Southlands Remediation and Development Project – Modification under S.75W of Project Approval - 06_0191 – Reconfiguration of Compensatory Flood Storage Basin, Reconfiguration of Lots 7, 8 and 9, Reconfiguration of Lots 3-6 Boundary, Addition of wording requested by OEH Accredited Site Auditor

Southlands – Detailed Design 2D Flood Re-Modelling – Addendum Advice Regarding Variation to Compensatory Flood Basin Design and Impact

Re: Orica Southlands - McPherson Street, Banksmeadow – Section 75W Modification
(MP 06_0191)

Southlands Industrial Estate **Figure D9a**
Final Development Scenario 50% AEP flood level difference map

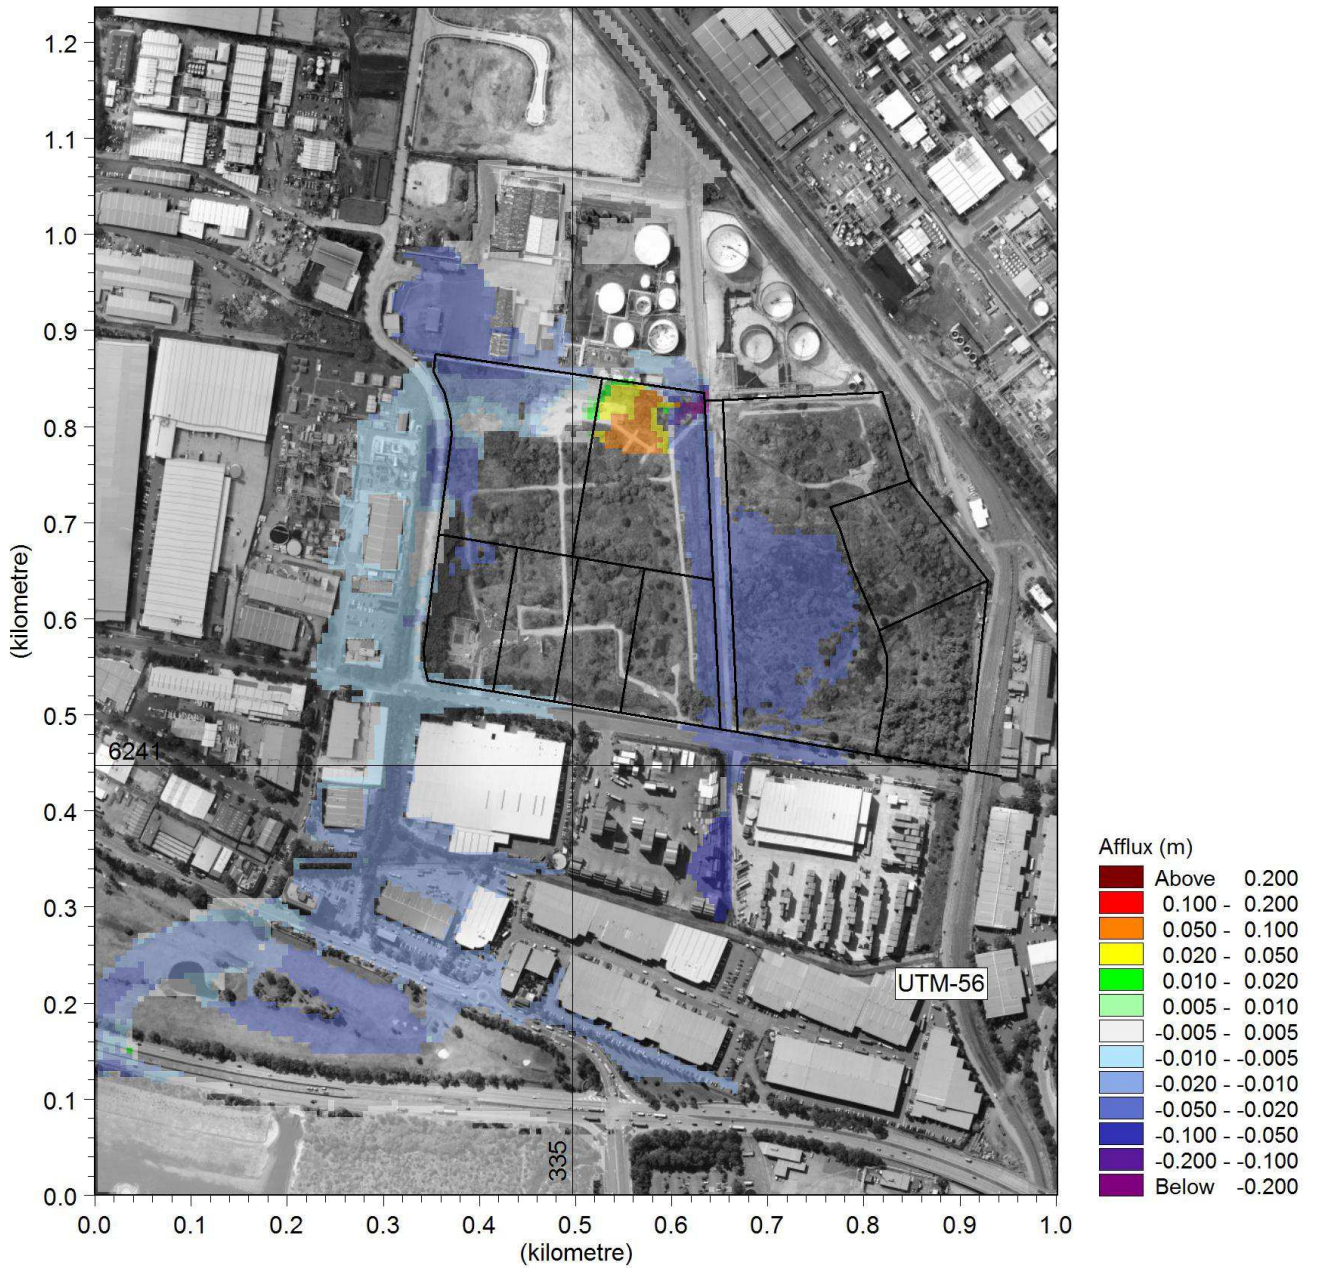
As per Consent condition 9, the flood difference maps for the 2 year (Figure D9), 10 year (Figure D10) and 100 year ARI events (Figure D11) have been reproduced in Figure D9a, Figure D10a and Figure D11a of this report, respectively.

Examination of these figures shows that there is no afflux on adjoining properties and in fact leads to a decrease in flood levels in most areas. There are some minor differences when comparing Figures D9a, D10a and D11a (attached to this report) with Figures D9, D10 and D11 of the Aurecon 2010 report, with some increases in flood level within the Southlands site boundary due to the changes to on-site mitigation measures.
